| ORIGINATOR       |            | MODEL FILE NAME - REVISION       |                                  |
|------------------|------------|----------------------------------|----------------------------------|
| SCALE @ A1       | 1:125      | EBE-STN-B07-ZZ-DR-X-005000 - C01 |                                  |

| PROJECT NAME          |            | DRAWING TITLE   |       |
|-----------------------|------------|---|-------|
| Ebury Bridge Phase 01 |            | Building B7 - South West Elevation - Proposed Precast Cladding Change From Terracotta to Sotech Aluminium |       |

SOUTH-WEST ELEVATION

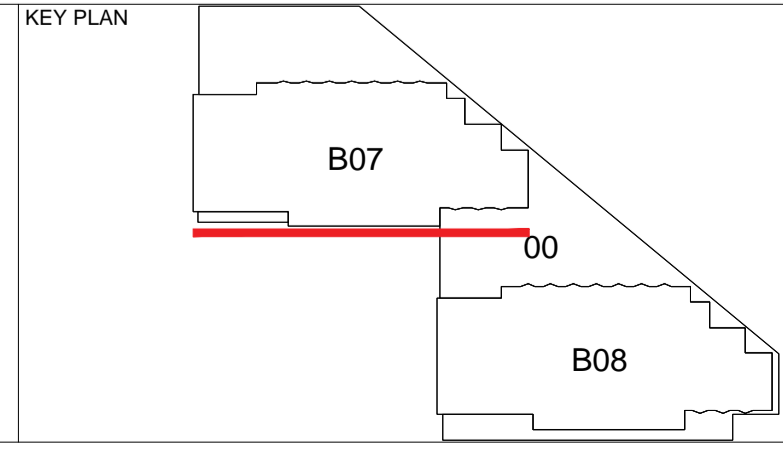
CLADDING TO FACE OF PRECAST LEVEL 12-16 (SHOWN IN RED BOX) AT SOUTH WEST/NORTH WEST CORNER IS PROPOSED TO CHANGE FROM TERRACOTTA TO ALUMINIUM. PLEASE REFER TO TYPICAL PLAN DETAIL EBE-STN-ZZ-ZZ-DR-X-031013 AND TYPICAL SECTION DETAIL EBE-STN-ZZ-ZZ-DR-X-0310021

CLADDING TO FACE OF PRECAST LEVEL 01-16 (SHOWN IN RED BOX) AT SOUTH WEST/SOUTH EAST CORNER IS PROPOSED TO CHANGE FROM TERRACOTTA TO ALUMINIUM. PLEASE REFER TO TYPICAL PLAN DETAIL EBE-STN-ZZ-ZZ-DR-X-031002 AND TYPICAL SECTION DETAIL EBE-STN-ZZ-ZZ-DR-X-0310019

| ALL REVISIONS |     | MAIN CONTRACTOR |  | CLIENT LOGO |                 |
|---------------|-----|-----------------|--|-------------|-----------------|
| S4            | C01 | 21/11/2023      | Precast cladding (corners marked in red boxes) change showing Sotech Aluminium cladding replacing the Terracotta cladding. | SB          | SB   SB   SB    |
